**RE: LEWIS LANDING
FILE #SE 023-1308**

Enclosed are 2 sets of revised plans that have been revised in response to the November 20, 2019 comment letter from GCG Associates, Inc. Our responses are as follows:

EMERGENCY SPILL WATER GRATE

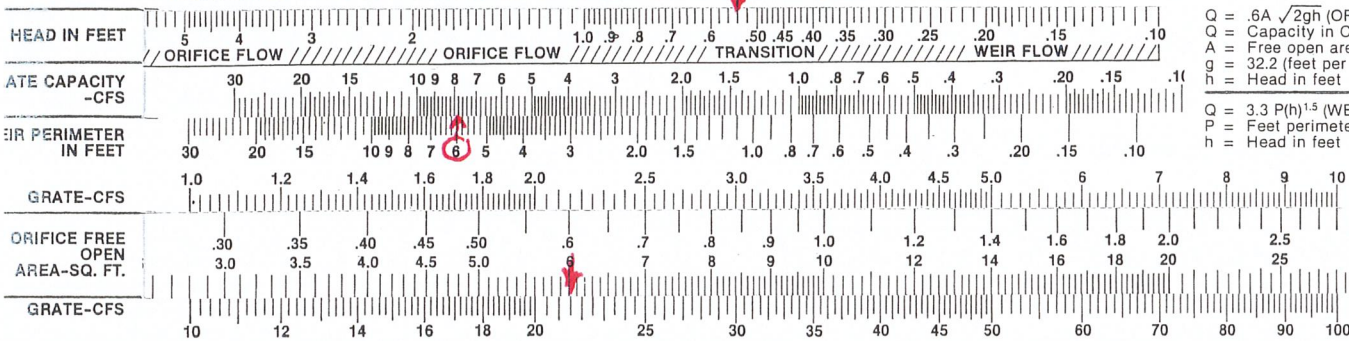
- 8) Attachment B demonstrates that the emergency spill water (inlet grate) has the capacity to pass the 100-year storm. If that failed, the excess flow would go over the drive to the wetlands.

The specific stool-type inlet grate has 2.5 square feet of openings. With a .54 head, it can pass 7.94 CFS which is the peak inflow to the detention basin. Therefore, with a brim-full basin, the emergency spillway can safely pass the 100-year peak inflow without over tapping the dike.
